RE: Response to Ohio EPA Notice of Deficiencies dated December 11, 2012
Contiguous Expansion PTI Application
Apex Sanitary Landfill
Jefferson County, Ohio

ATTACHMENT A
RESPONSE TO OHIO EPA NOD DATED DECEMBER 28, 2012
CONTIGUOUS EXPANSION PTI APPLICATION
APEX SANITARY LANDFILL
JEFFERSON COUNTY, OHIO

Comments from Attachment A – General Engineering Review

Figure 2

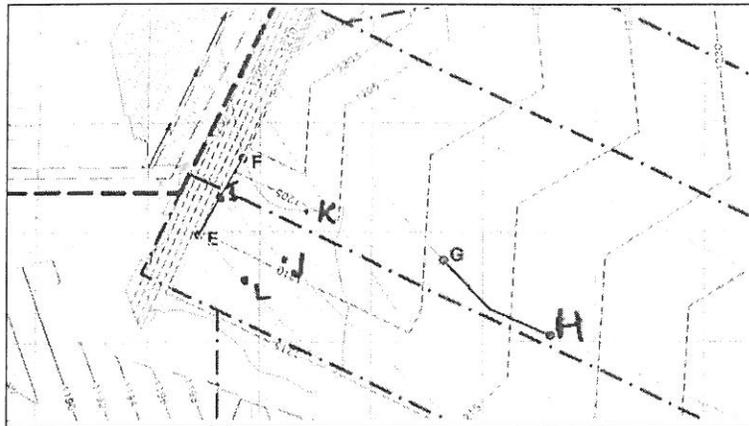
Comment No. 9 – The structural fill area on the west side of phase 7 was not evaluated sufficiently for settlement. Please add the settlement points indicated in Figure 2 and evaluate them for settlement. When this evaluation is complete, the consultant will determine that the slopes in these area do not meet the regulation and the design will need to be revised in this area (see Table 2).

Response: The settlement calculation has been revised to include the analysis of points in Figure 2. Based on the results of our revised calculation, the post settlement slopes in this area meet the minimum slopes required. The revised calculations are provided in Section (C)(4).
